RESPONSE TO SUBMISSIONS: TALAVERA ROAD DATA CENTRE CAMPUS EXPANSION (IC3 SUPER WEST)

17 – 23 TALAVERA ROAD, MACQUARIE PARK
LOT 527 DP 752035

RESPONSE TO SUBMISSIONS REPORT

SSD-24299707

Figure 2: Existing and Proposed Easement Alignments (Source: Northrop, 2022)

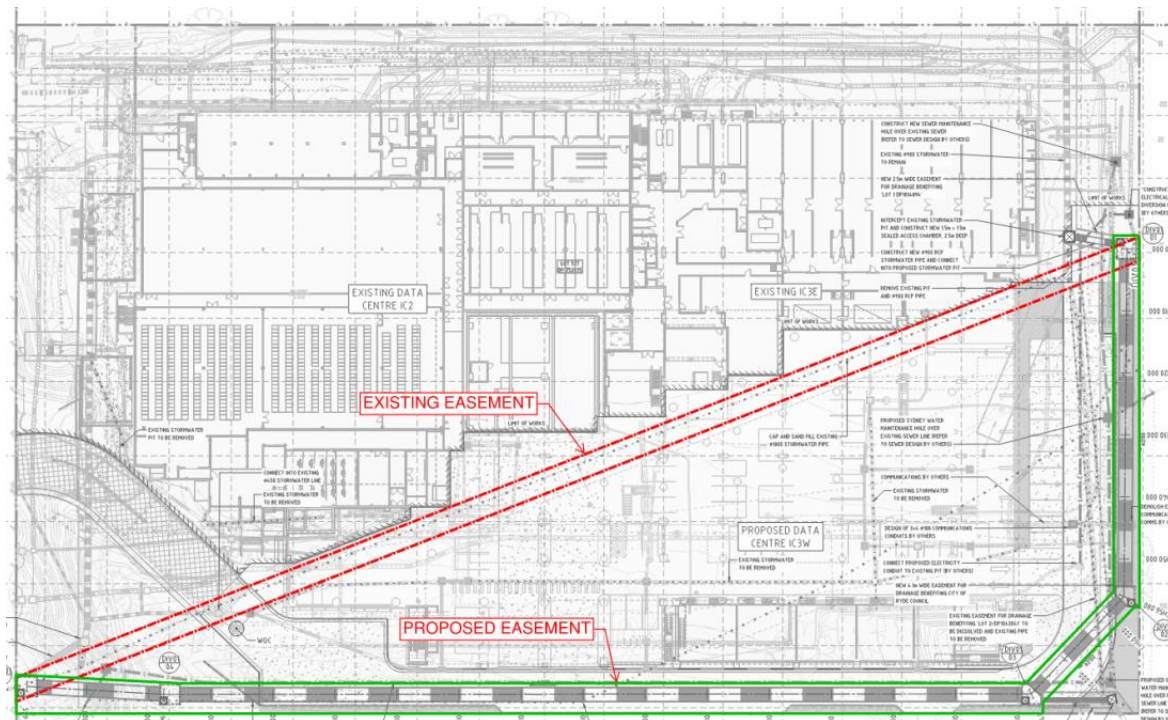
As part of discussions with City of Ryde Council, the proposal to relocate the existing easement to outside of the building undercroft was explored. Subsequent various alignments for a new proposed easement were developed for City of Ryde Council's review. Consequently, the option to relocate from the middle of the site to be along the southern and western boundary was agreed upon with Council, as shown in **Figure 2**.

The proposal has been amended to include the construction of a new 2,100mm stormwater line and associated easement, in accordance with the Terms Sheet proposed to City of Ryde Council, which closes out many of the matters raised by the City of Ryde Council. This includes the diversion of the trunk stormwater infrastructure to the perimeter of the subject site, and at the same time, upgrading to a 2,100mm pipeline.

The option to place the alignment near the boundary was ultimately chosen to minimise the potential number of clashes with the existing services pipes. This alignment also provides City of Ryde Council with less obstructions for maintenance and access if required.

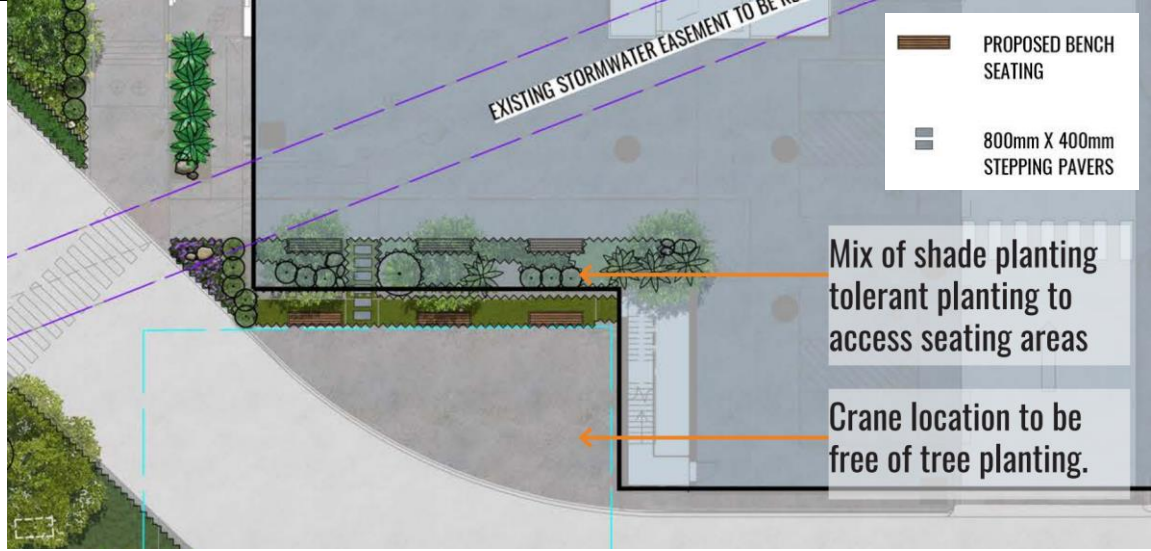
1.6. Communal Open Space (COS)	<p><i>No consideration has been given to the provision of ground floor communal open space areas which afford amenity to staff members and visitors to the site. Given the scale of the development and nominated personnel to be on site as outlined in the Plan of Management, it is considered important that quality useable communal open space is provided on site. Given the lack of communal open space, additional concern is raised in relation to the ability of any COS to provide suitable levels of solar access.</i></p>	<p>Due to the nature of the facility, and the typology of the ground floor (vehicle movements, parking, and a perimeter access roadway) there are limited opportunities for communal open space. There is also a necessity to provide permanent hardstand locations for craneage of rooftop plant for installation and replacement. There is also a desire for visitors to report to security immediately and not to loiter in common areas (unaccounted for).</p> <p>To best accommodate the above safety and security requirements and provide an amenable communal open space, the project proposes seating be provided along the fringes of the landscaped area adjacent the entrance of the facility. This location is within acceptable range of the data centre security, and limits any interaction with vehicle movements and negates the requirement to cross the perimeter roadway.</p>

TABLE 11: RESPONSE TO AGENCY SUBMISSIONS			
SUBMITTER	MATTERS RAISED	COMMENTS / REQUESTS	FORMAL RESPONSE
			 <p>Figure 19: Proposed Communal Open Space Area (Source: Geoscapes, 2022)</p> <p>Details of the area proposed include:</p> <ul style="list-style-type: none">▪ The area is north-west facing thus providing a year round setting for gathering.▪ This location will likely be utilized for internal and external social / corporate gatherings. <p>The nominated opportunity is adjacent a hardstand which is a designated crane zone (very rare use requirement); this will exclude the ability to erect any permanent structures to this zone.</p>
